Re: **Application for Subdivision and Site Plan Review
Assessor's Map 210, Lot 02
200 Chase Drive
Altus Project #P4950**

At the October 1, 2019 Technical Advisory Committee (TAC) meeting, Altus Engineering presented the proposed Subdivision and Site Plan Review applications for the 200 Chase Drive on behalf of the Bethel Assembly of God and 200 Chase Drive, LLC. The TAC provided comments on the proposed design, which have since been addressed in the revised submittal package. The following written comments were provided by TAC with Altus' responses are below (in Red):

SITE PLAN

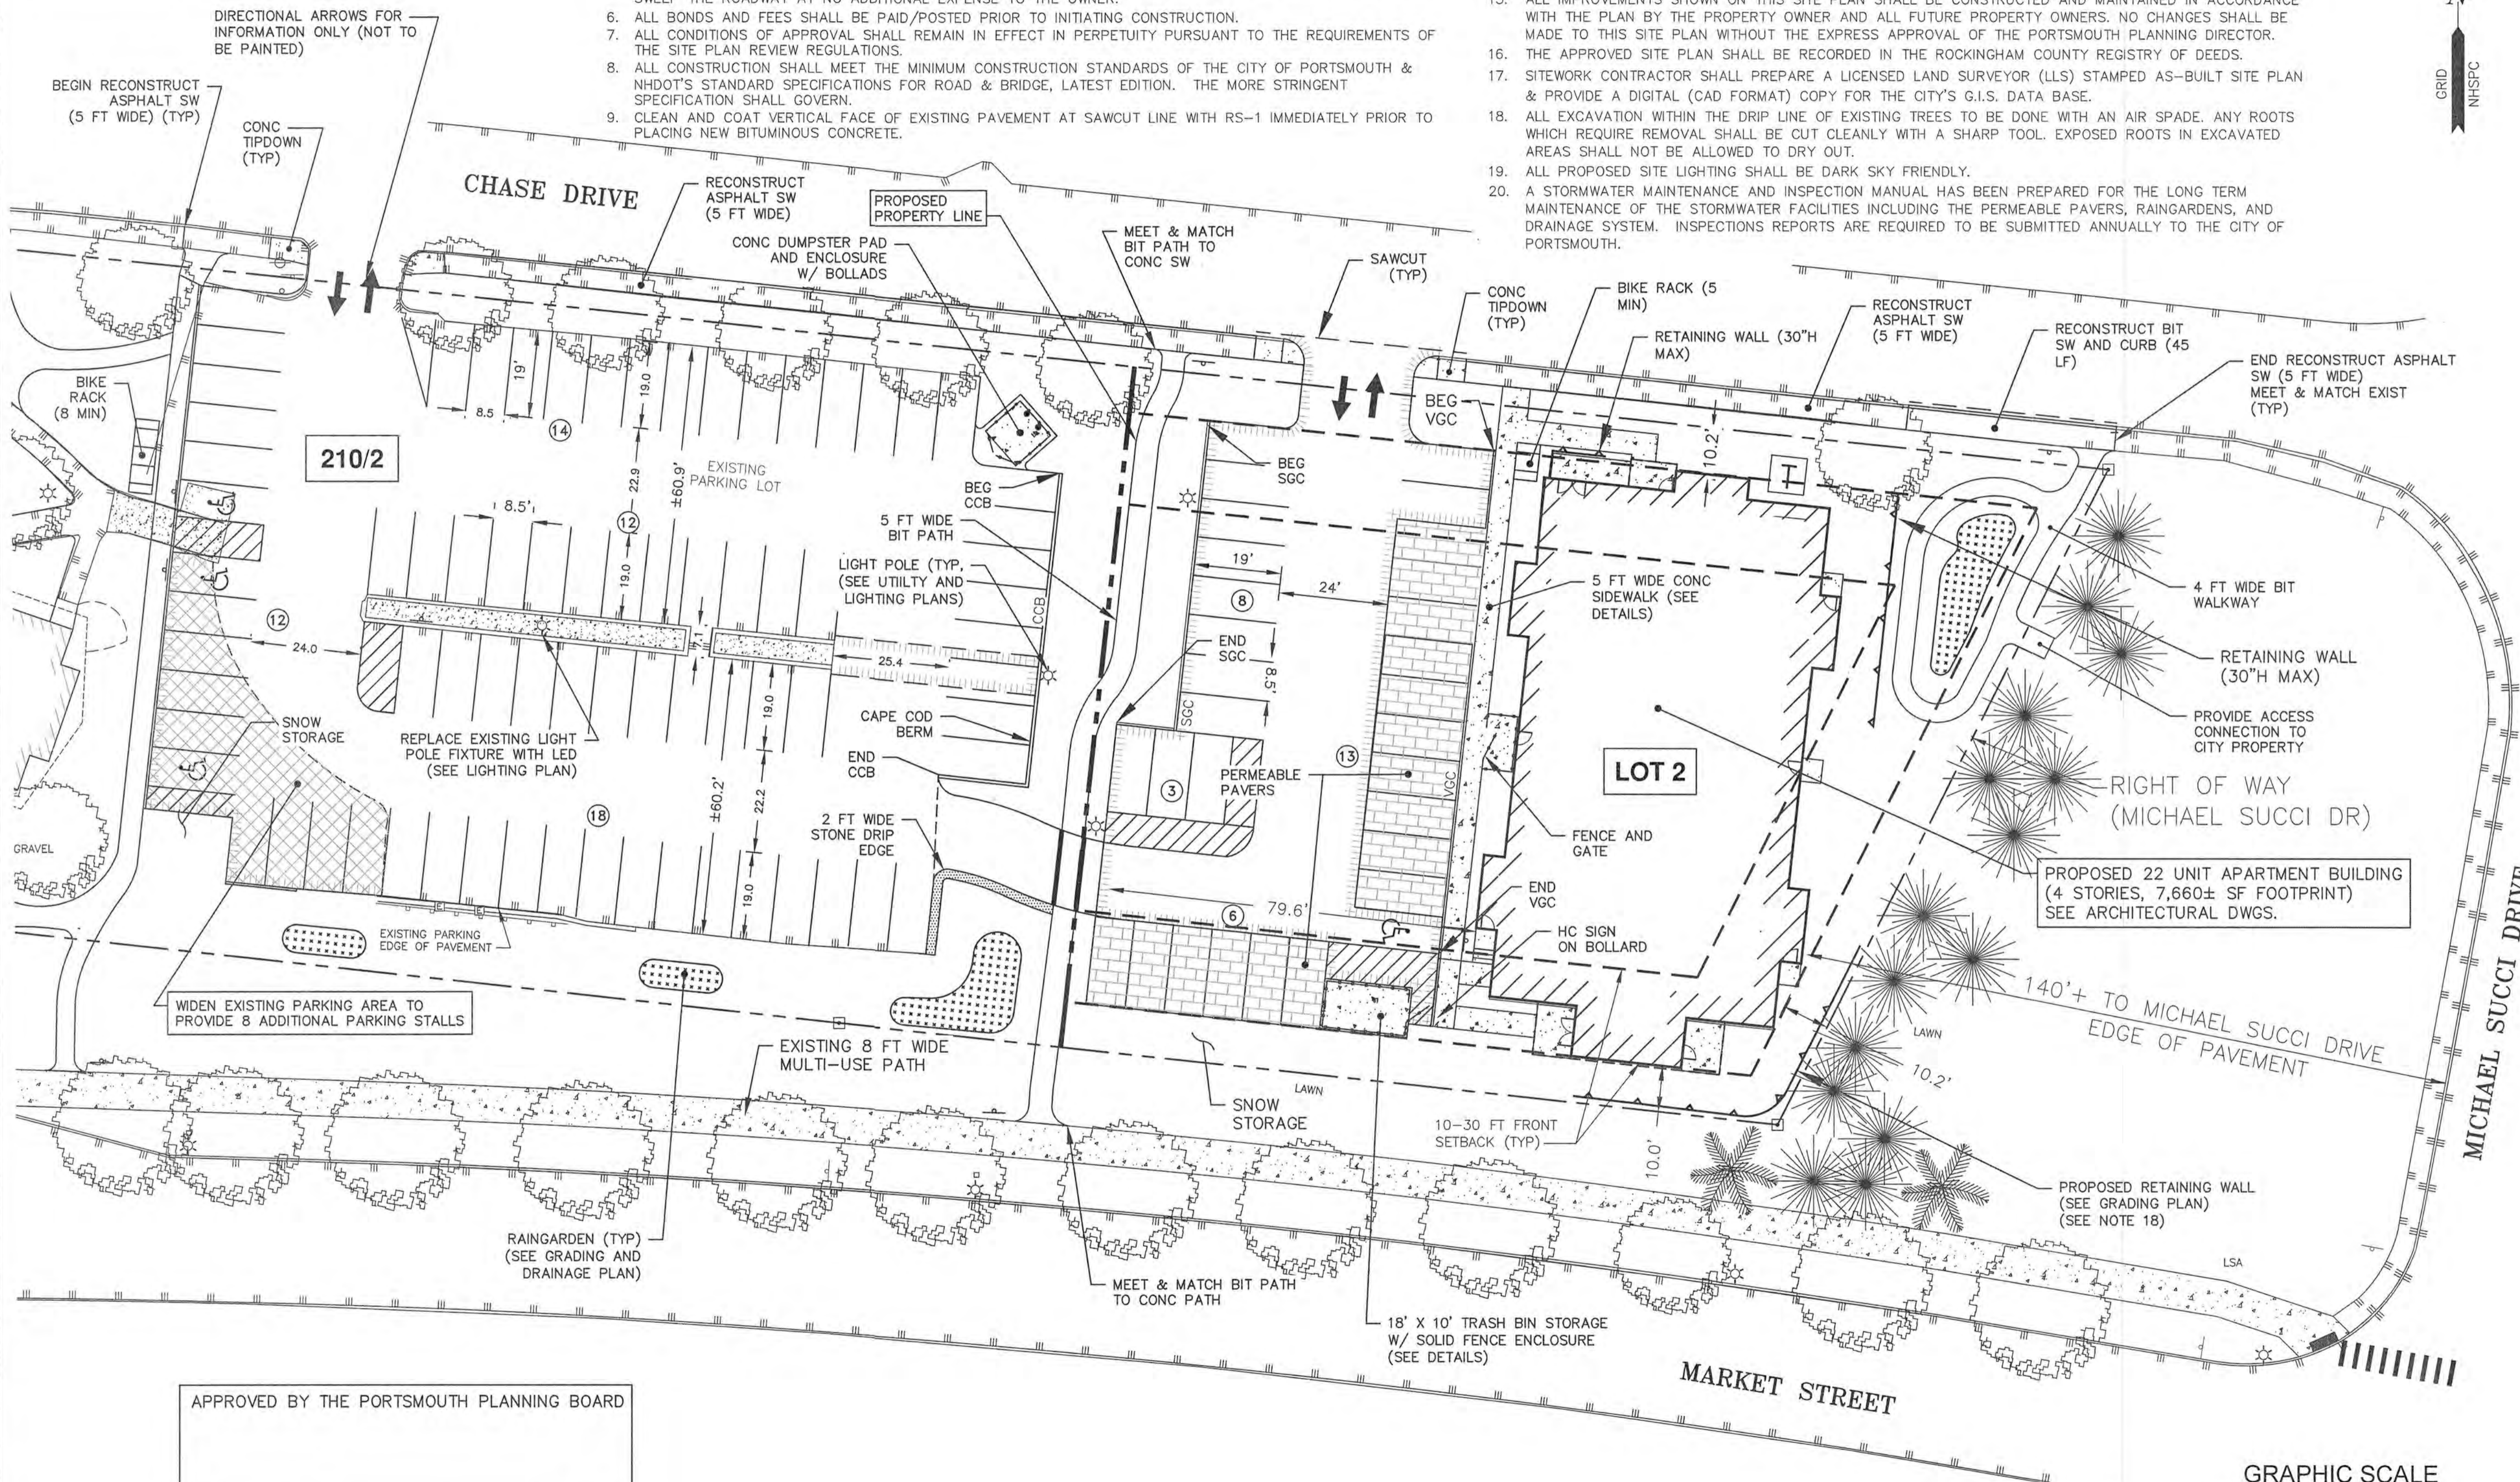
- *A note should be added to the site plan referencing maintenance requirements for both raingarden and porous pavers.*
 - *A note has been added to both the Site Plan (sheet C-4) and the Grading and Drainage Plan (sheet C-5).*

TITLE:
 UTILITY PLAN
 SHEET NUMBER:
 C.8

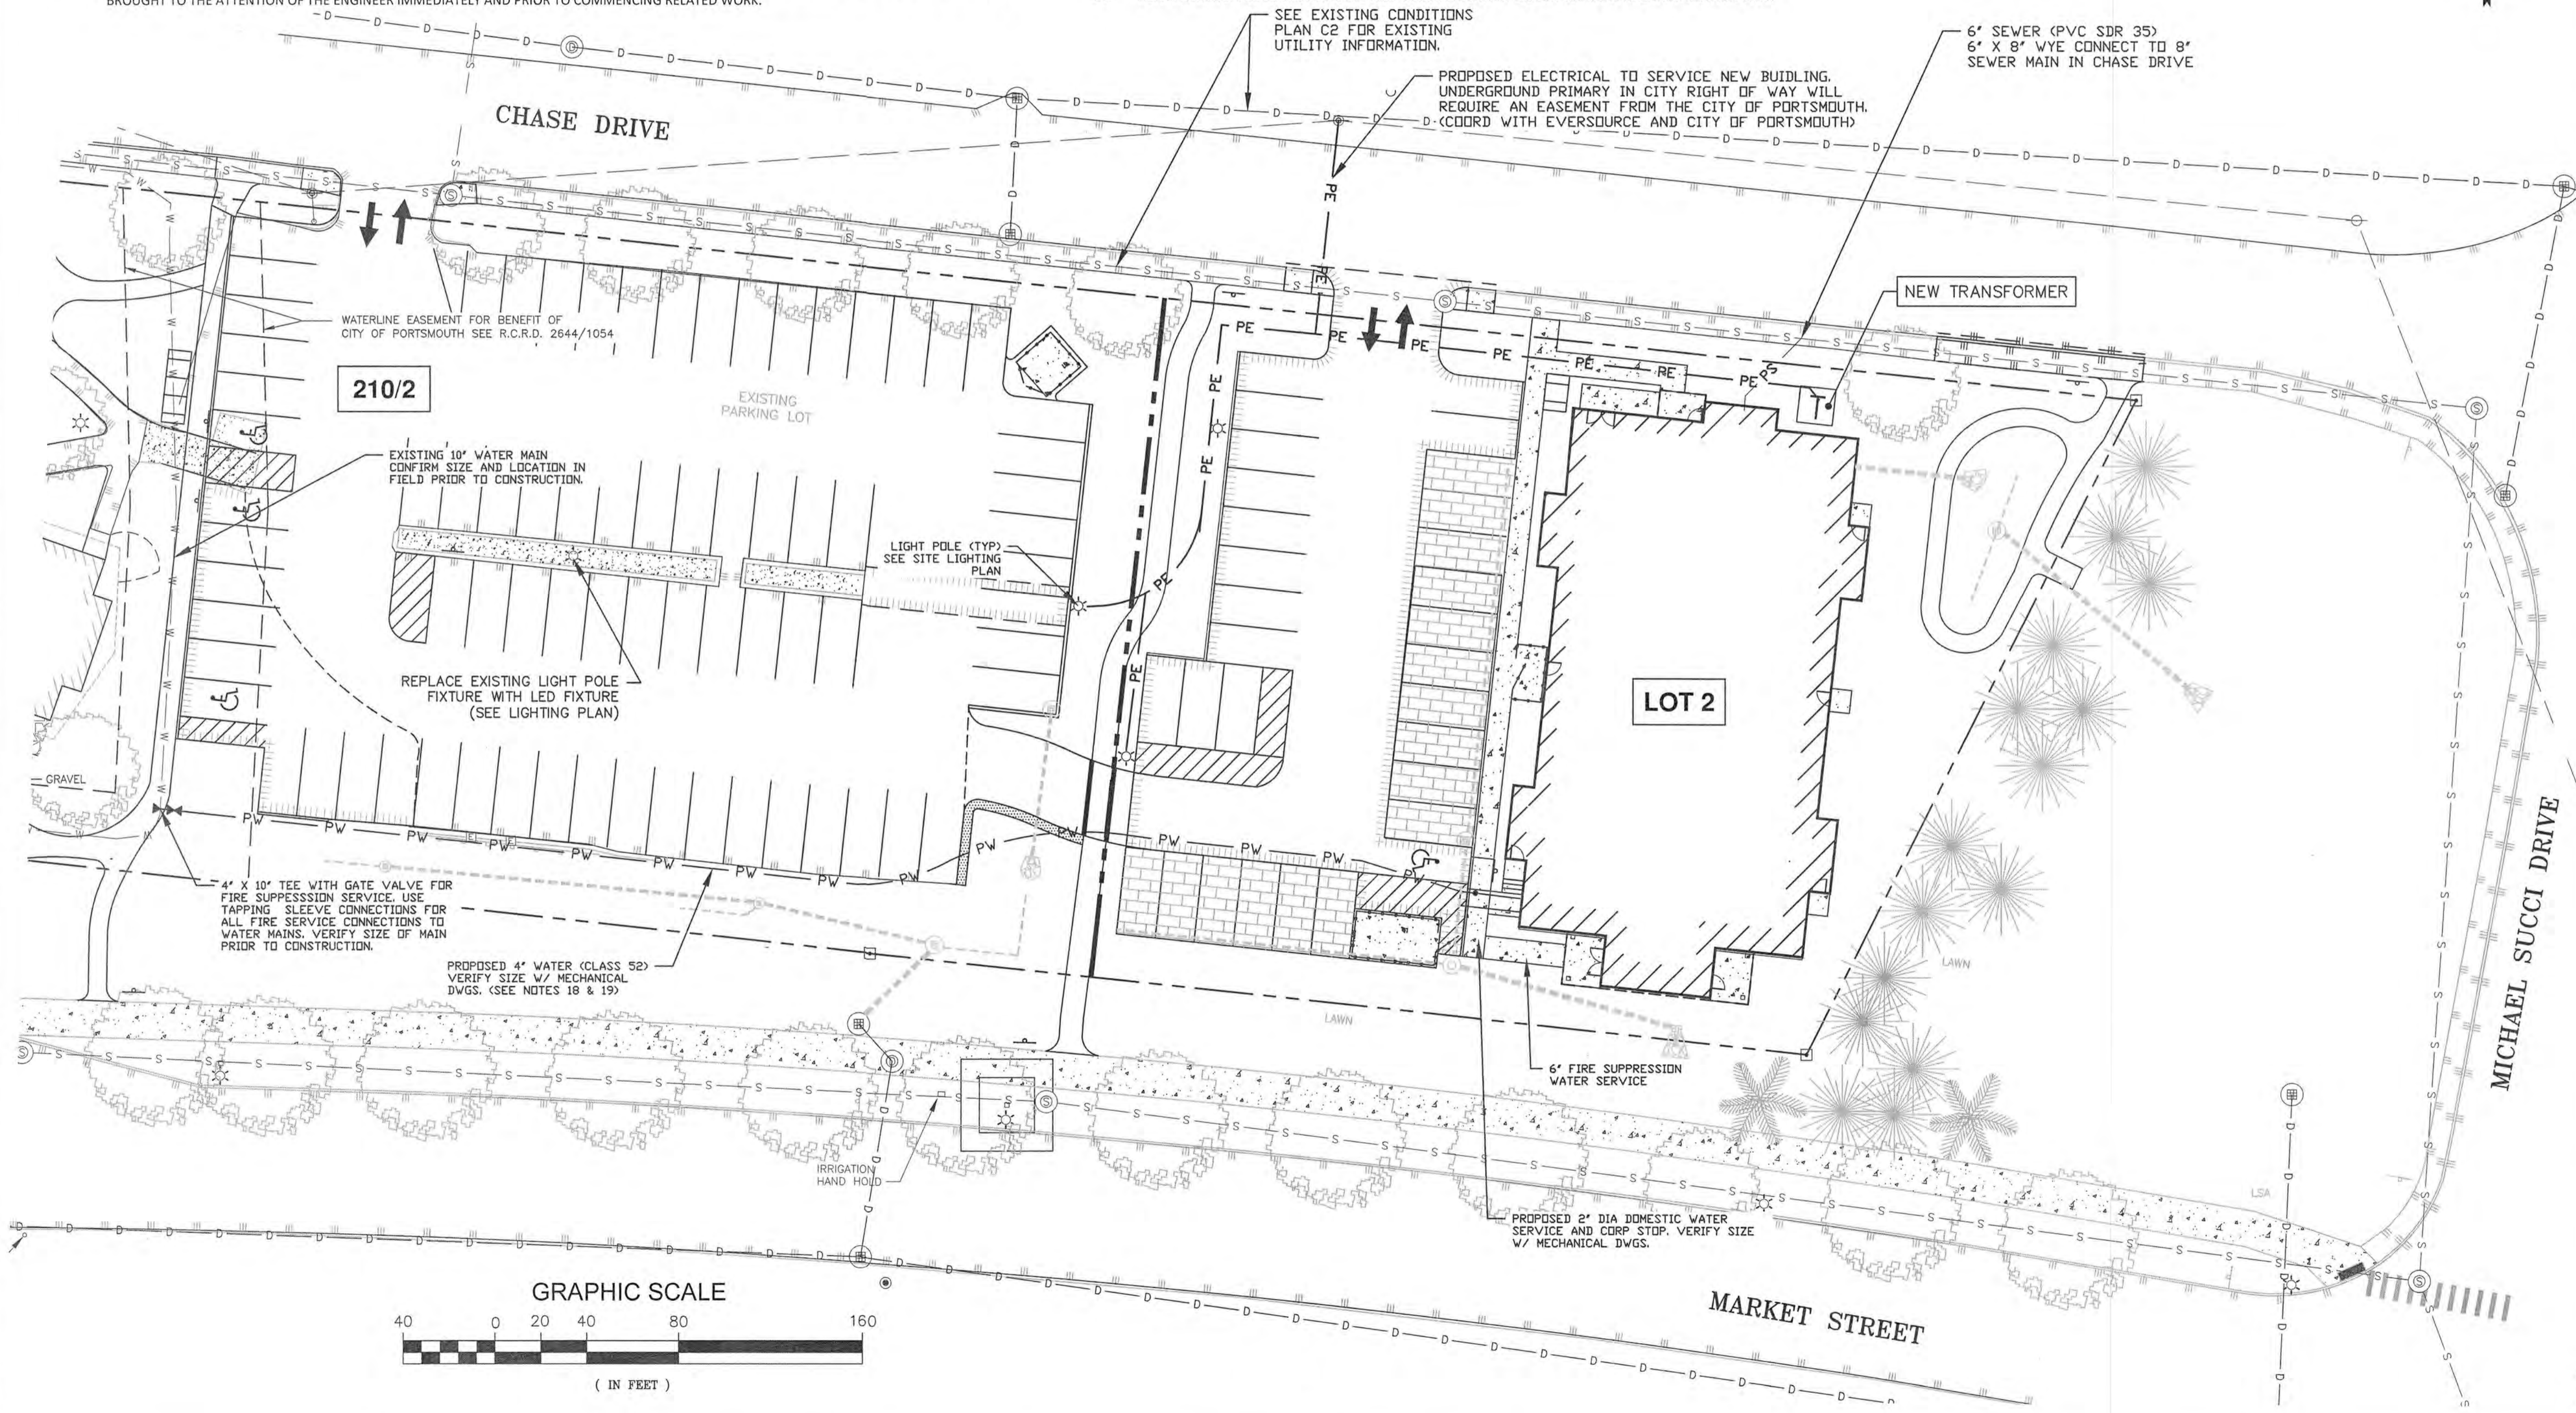
- *The utilities crossing Chase Drive will require a license.*
 - *A note has been added to the Utility Plan, sheet C-8.*

- *Property owner to provide a blanket easement to access water valves on site and do leak detection. The applicant is showing 1-6" water line heading to the building. This pipe may be too large to provide proper water quality. For this reason, the applicant may need to run two separate services to the building from the main.*

- *A note has been added to sheet C-8 that an easement will be required.*
- *The parking demand analysis did not include a count of the number of cars in the parking lot. Only the number of people in attendance at each service was counted, and it was assumed that they came 3 to a car. There must be more to document the vehicle occupancy rate than a guess. The number of cars in the lot, not the number of people in the building, is critical to a parking demand analysis. The number of vehicles in the parking lot must be counted to provide a valid analysis.*

COMMUNITY SPACE PLAN

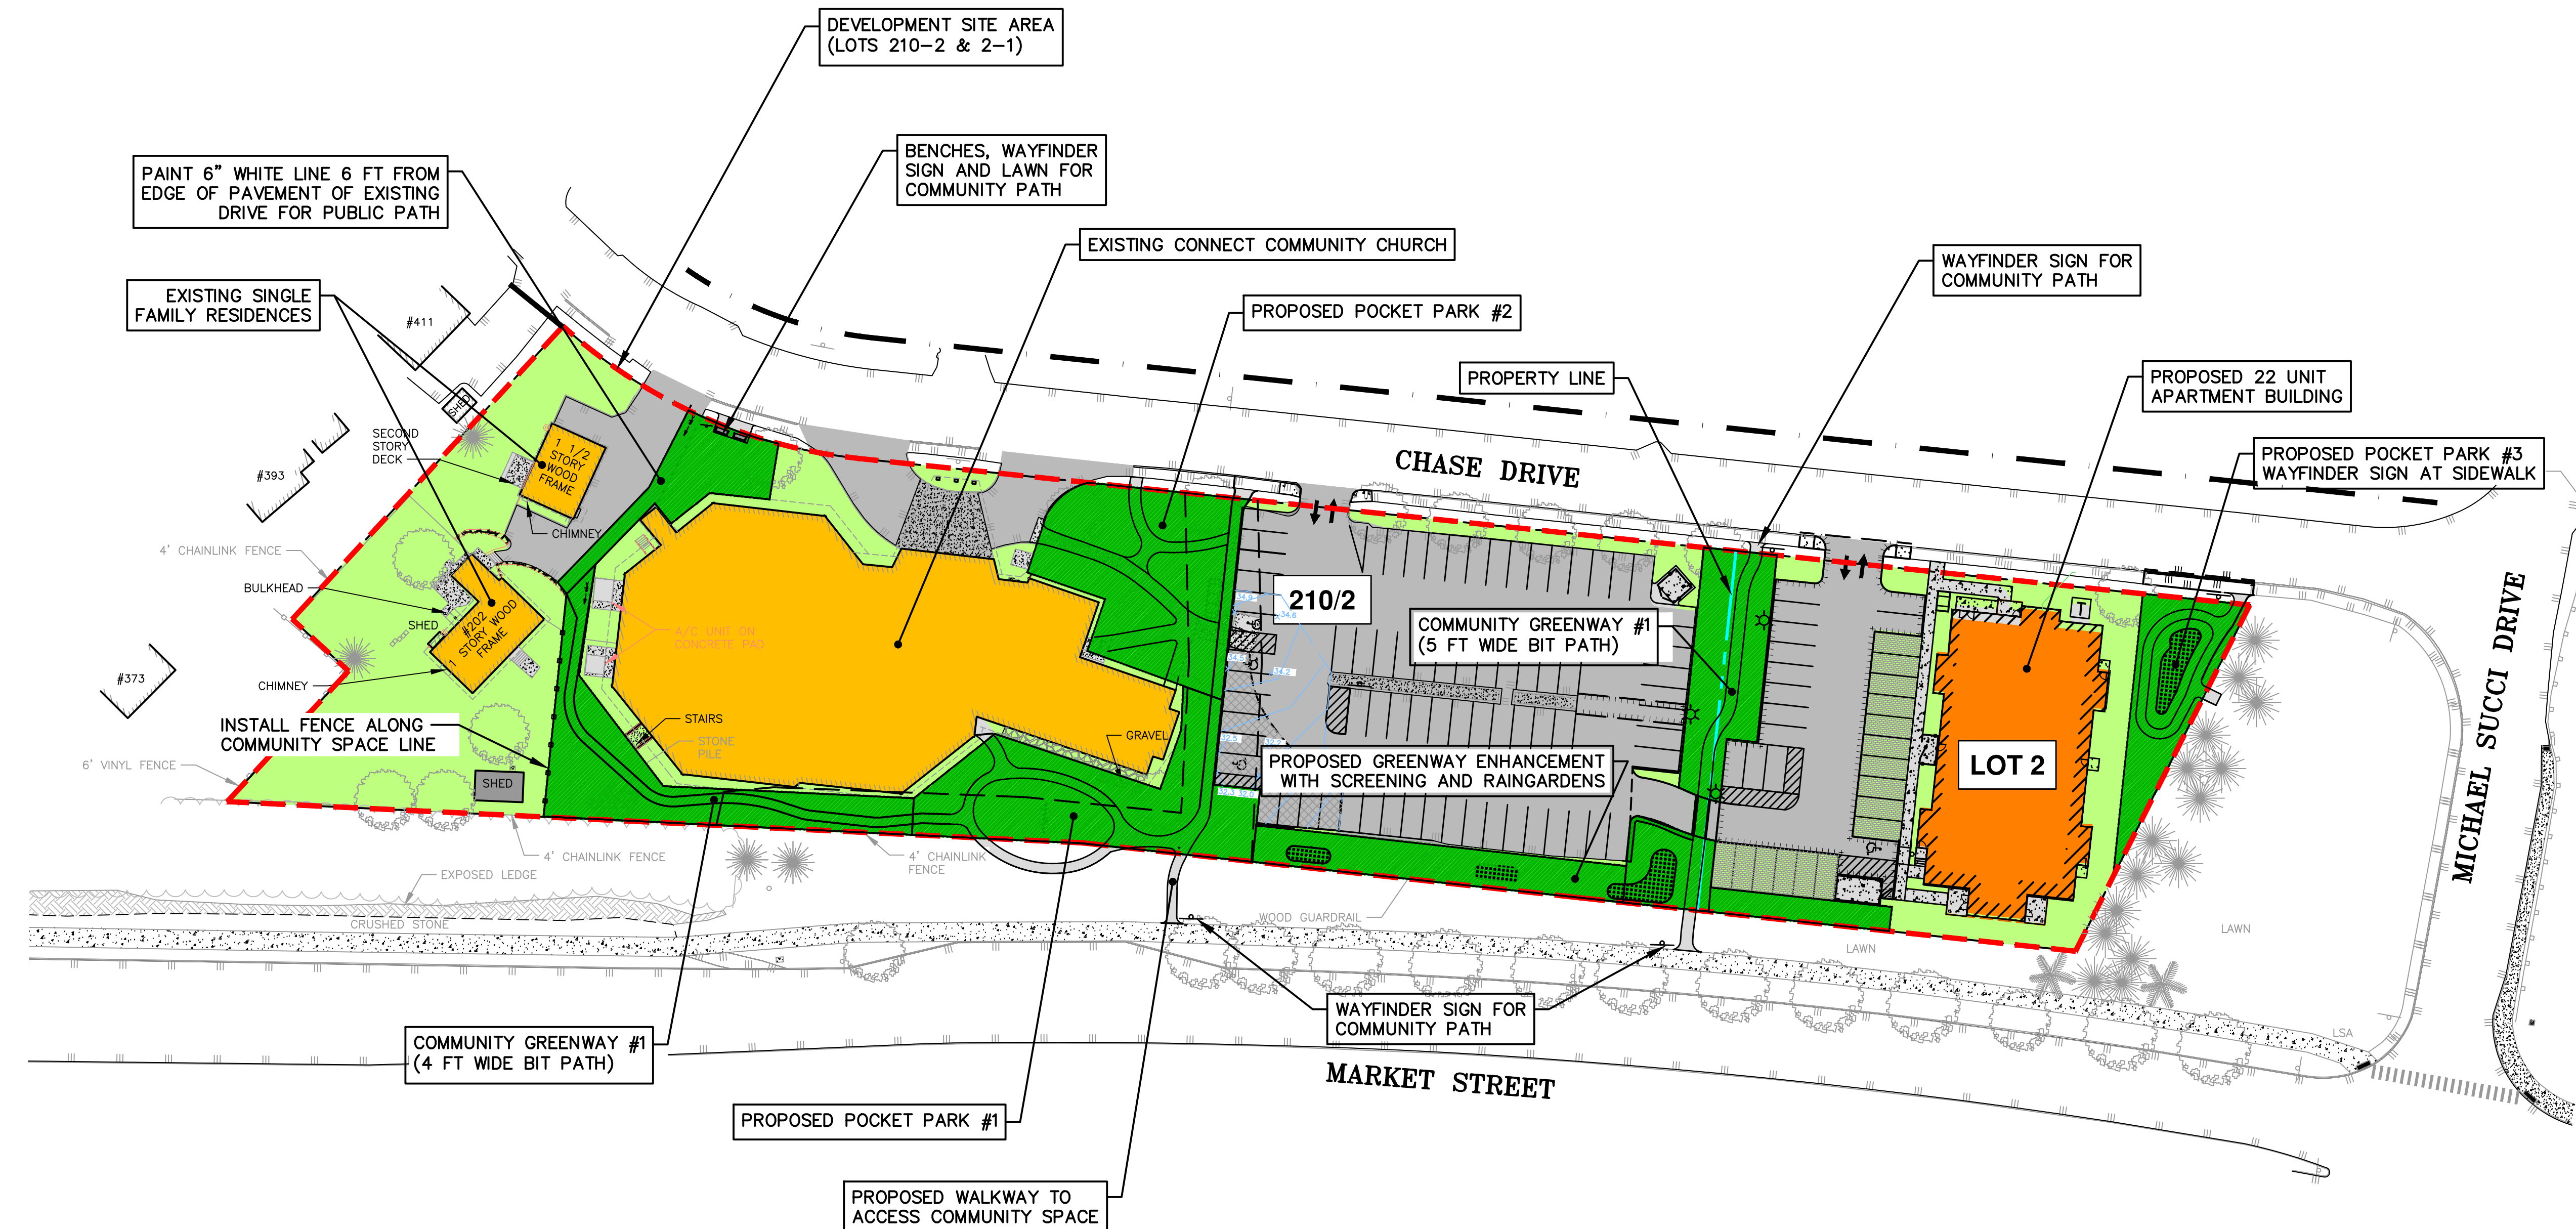
- *Community space calculations need to be broken down into the respective types (and then be itemized and listed on the overall site plan).*
 - *A table has been provided on the Community Space Plan and the Overall Site Plan with the Community Space types and areas. 22.2% of the site is provided.*
